Idle Fluctuation in Park or Neutral

Service Category Engine/Hybrid System

Section Engine Control

YEAR(S)	MODEL(S)	ADDITIONAL INFORMATION
2015 - 2016	FR-S

Figure 1. Location of Authorized Modification Label on 2015 FR-S

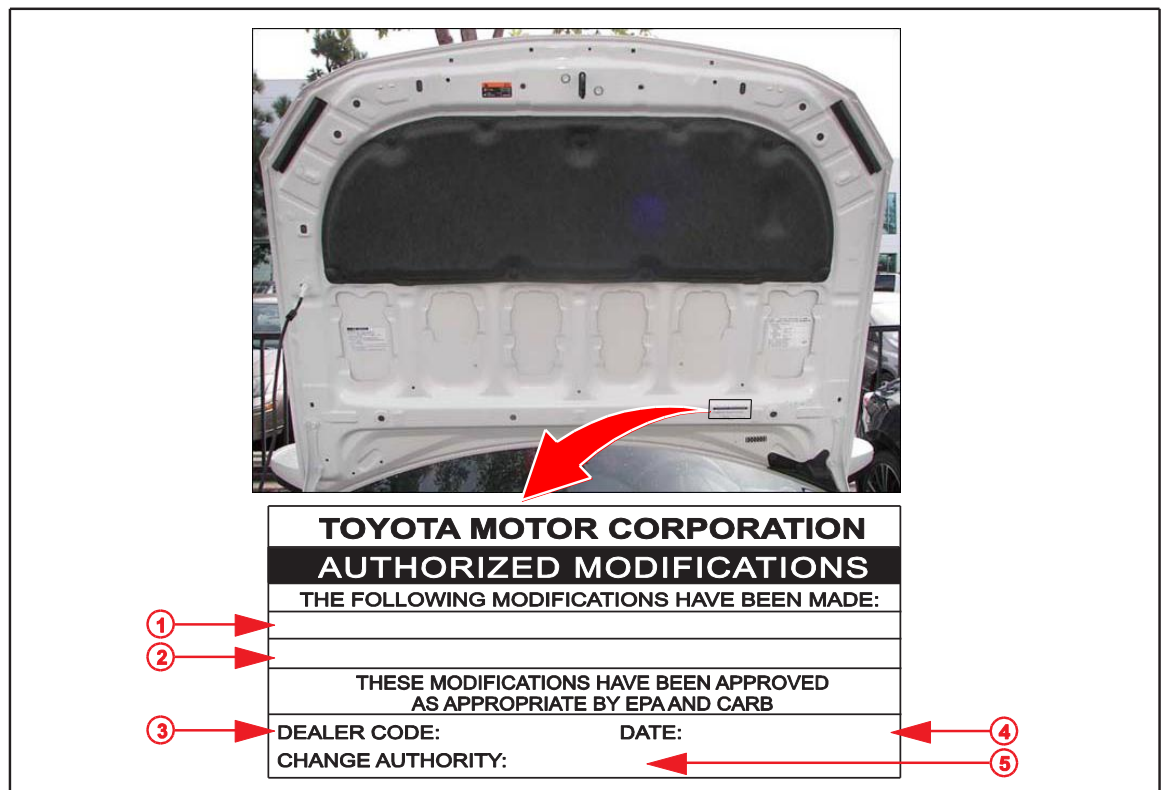
1. Confirm the condition as described in the Introduction.
2. Confirm calibration applicability.
3. Reprogram the TCM.
 - A. Check for the Authorized Modifications Label affixed to the vehicle in the location shown in Figure 1. Confirm if the TCM calibration has been updated. If the calibration ID listed is NOT the latest TCM calibration - go to step 3.B.

(2) Affix the Authorized Modifications Label to the vehicle at the location shown in Figure 1. The Authorized Modifications Label is available through the MDC, P/N 00451-00001-LBL.
